SEWAGE DISPOSAL SYSTEM

MARYLAND STATE DEPARTMENT OF HEALTH

SUBDIVISION Bruffey Property ROAD 14730 Triadelphia Mill LOT 1

PROPERTY OWNER Robert Learmouth

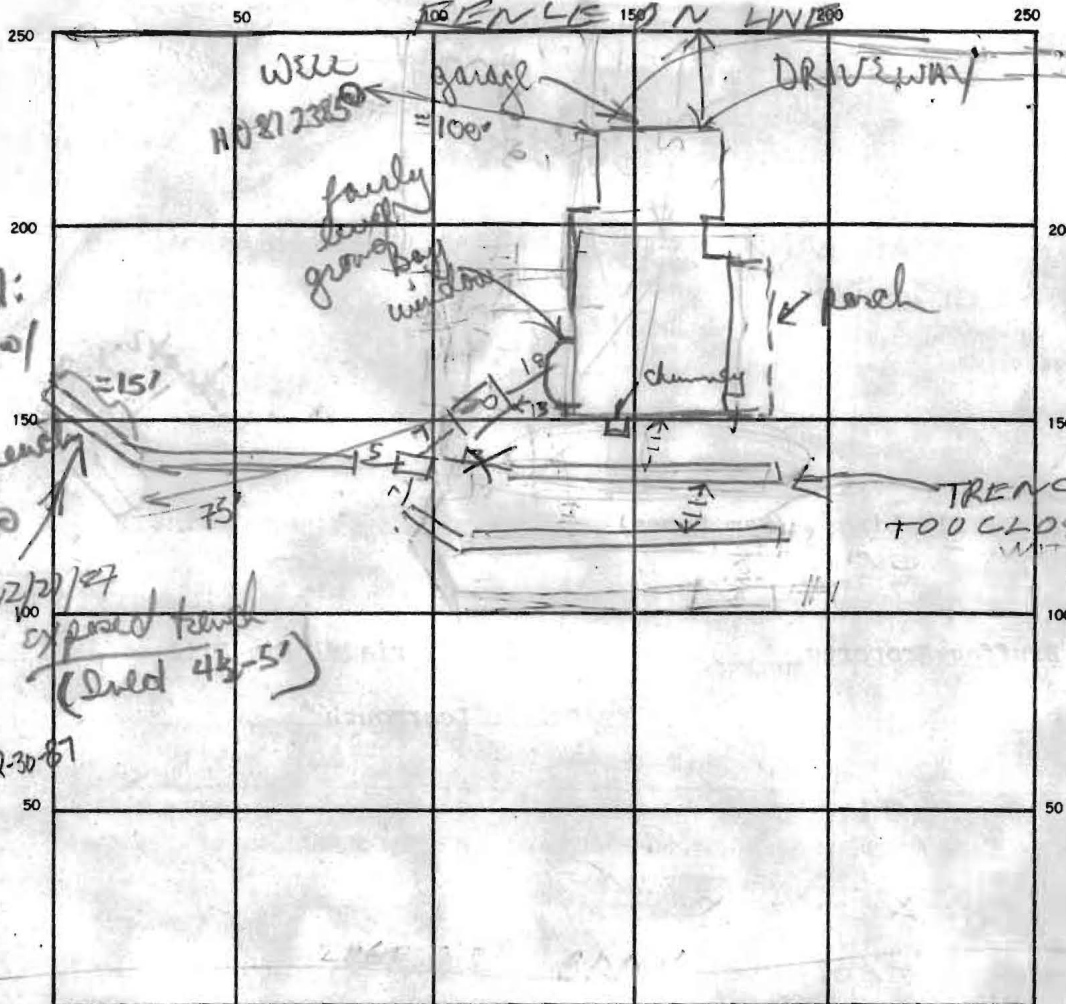
11/17/87 TRENCH #2 IS TOO CLOSE TO HOUSE (HOUSE HAS CELLAR)

ONLY 3 BED ROOMS. TRENCH #2 WAS DISCONNECTED NOW

TRENCH #3 MUST BE LENGTHENED 13 FT LONG 3 FT WIDE

5 FT DEEP 1 1/2 FT STONE COVER TRENCHES & TANK B/I

12/21/87 area of ~ 15' of trench exposed. Direction of trench

completely different than shown. Hard to say how it connected to existing. Cap for S.T. c/o missing. 12/22/87 Owner knows c/o needed system at that info
